RE: NEW MEXICO MORTGAGE FINANCE AUTHORITY (K-14/D73)

(344 4th St SW)

ENGINEERS CERTIFICATION FOR CERTIFICATE OF OCCUPANCY

GRADING and DRAINAGE PLAN

# ENGINEER'S CERTIFICATION

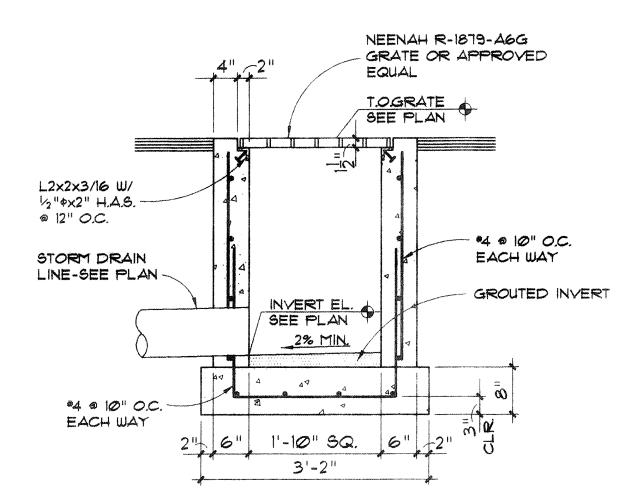
The S.O. #19 on the Engineers Certification requires the City's storm drainage inspector's signature prior to approval of the Permanent Certificate of Occupancy as per the Design Process Manual (DPM) Chapter 17 "Private Storm Drain Facilities within a City Right-of-Way and/or Easement"

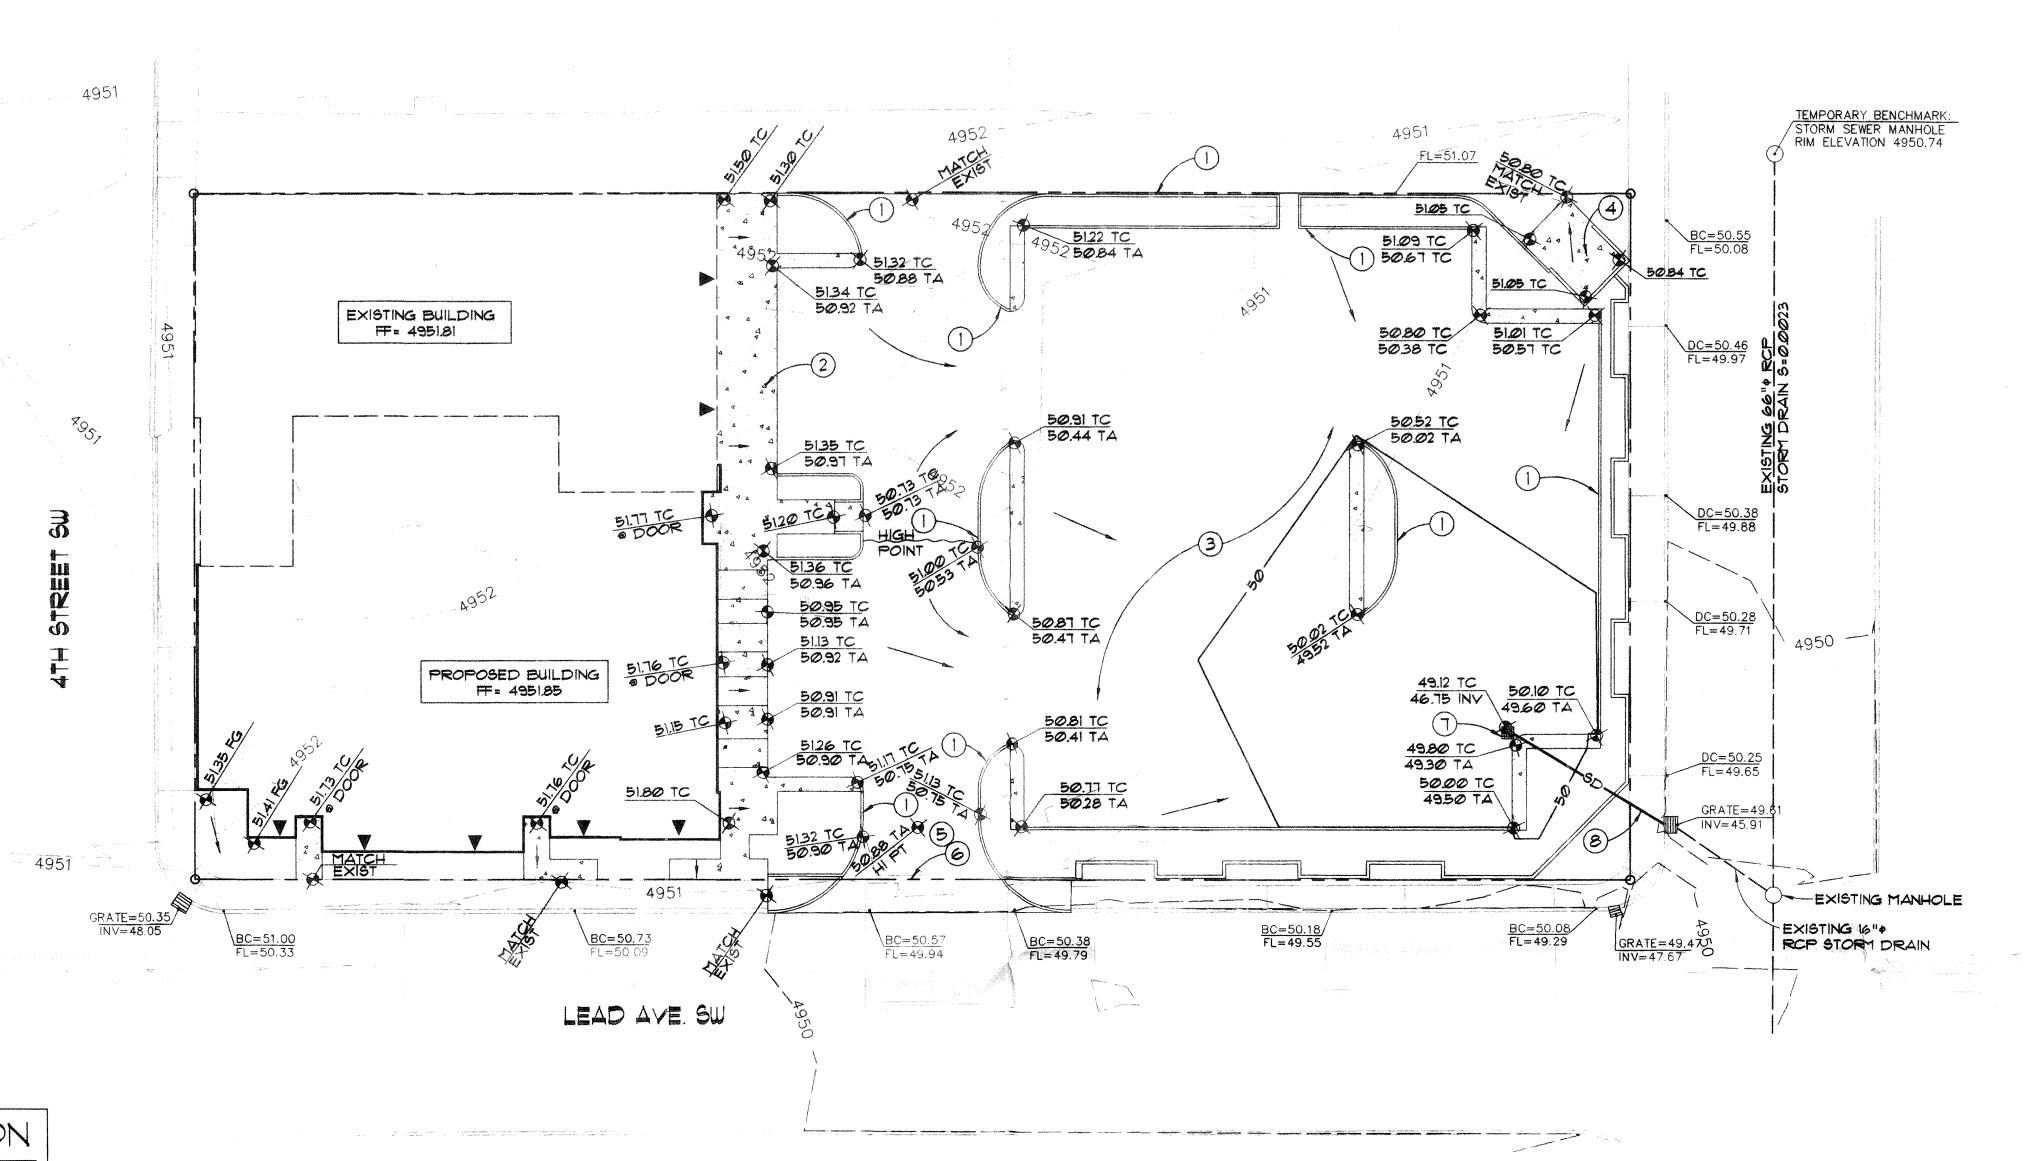
Note: On future submittals, the Engineers Certification MUST be made on the original grading and drainage plan which was approved for building permit showing the original engineers stamp date verses replotting the grading and drainage plan with all new asbuilt data. The original elevations are crossed out, with the asbuilt elevations then inserted on the grading and drainage plan. Any submittals which do not follow the above criteria will add time and concerns to the process.

Note: For future reference, the Engineers Certification *must* be made on the original grading and drainage plan which was approved for building permit showing the original engineers stamp date verses replotting the grading and drainage plan with all new asbuilt data; The original elevations are crossed out, with the asbuilt elevations then inserted on the grading and drainage plan. (For this project, the as-built elevations dated 4/10/2001 should have been made on the approved plan dated 2/9/2000). Without this process, it takes considerable time to review both sets of grading and drainage plans.
